UNITED STATES PATENT AND TRADEMARK OFFICE

APPLICATION NO.	FILING DATE	FIRST NAMED INVENTOR	ATTORNEY DOCKET NO.	CONFIRMATION NO.
10/033,516	12/24/2001	James A. Gravelle	P0120	8647

Office Action Summary

DETAILED ACTION

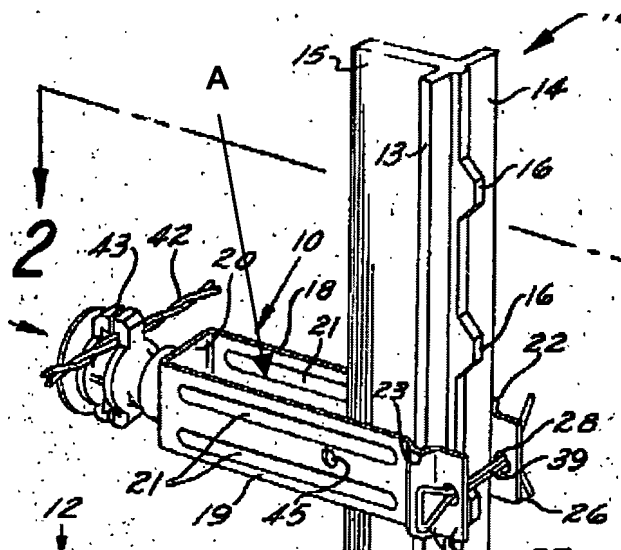
a third slot **A** (passage **A** between bracket arms **18,19** defining a slot; Figure 1 reprinted with annotations below) adapted and constructed to receive a leg of the fence post, the third slot being generally perpendicular to the first and second slots;

whereby the bracket can be mounted to the post in a first position in which the leg is received in the third slot, and a second position in which the leg extends opposite the third slot (Figure 1).

As to claim 7, Wilson discloses a support bracket **10,11** having a reinforcing rib **21** adjacent to a third slot (Figure 1).

Examiner does not agree. As to claims 1, 8 and 15, Wilson discloses a support bracket having a third slot **A** (the passage **A** between bracket arms **18,19** defining a slot; Figure 1).

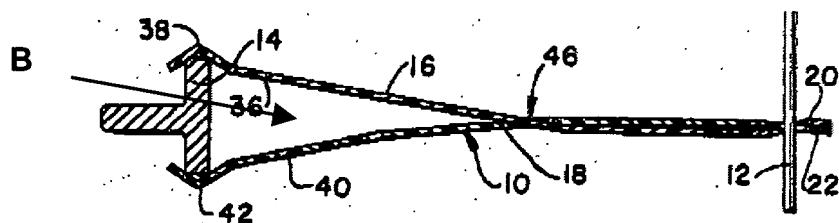
a third slot **B** (passage **B** between bracket arms **36,40** defining a slot; Figure 2
reprinted with annotations below) adapted and constructed to receive a leg of the fence
post (column 4 lines 11-14), the third slot being generally perpendicular to the first and
second slots;

whereby the bracket can be mounted to the post in a first position in which the leg is received in the third slot, and a second position in which the leg extends opposite the third slot (Figures 1 and 2, column 4 lines 11-14).

Examiner does not agree. As to claims 1, 8 and 15, Hansen discloses a support bracket having a third slot **B** (passage **B** between bracket arms **36,40** defining a slot) in which a fence post leg is received in the third slot (column 4 lines 11-14).
